Pending License Amendment to Homestake Mining
Company Unraium Mill and Tailing Facility
(EDATS: SECY-2008-0473)

**Re: Homestake Mining Company Uranium Mill,
License No. SUA-1471, Docket No. 40-8903**

TECHNICAL MEMORANDUM IN SUPPORT OF MASE LETTER TO NUCLEAR REGULATORY COMMISSION REQUESTING TWO-YEAR DELAY IN APPROVAL OF LICENSE AMENDMENT FOR HOMESTAKE MINING COMPANY URANIUM MILL, SUA-1471, MILAN, NEW MEXICO

USGS Gauge: Rio San Jose near Grants, New Mexico

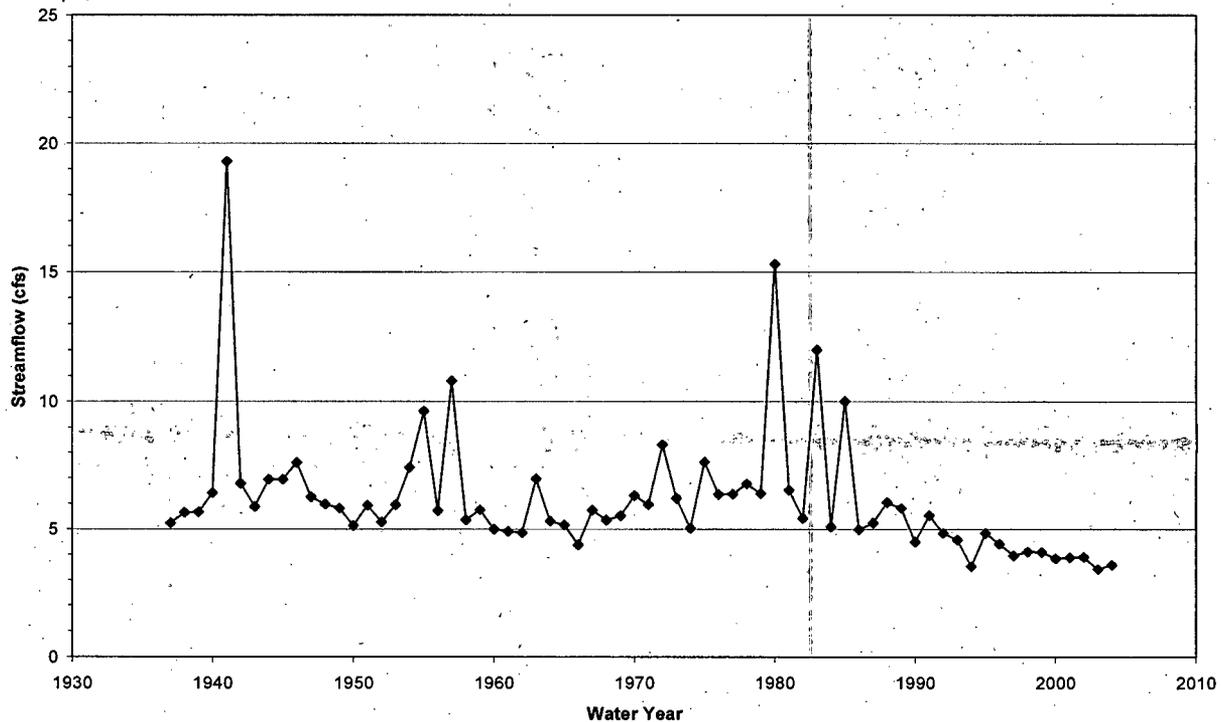
- As shown in the chart below, an alarming decrease in surface water flows in the Rio San Jose at a USGS gauging station near Grants has been documented by the Pueblo of Acoma. A regional assessment of the connections between groundwater and surface water flows is needed.
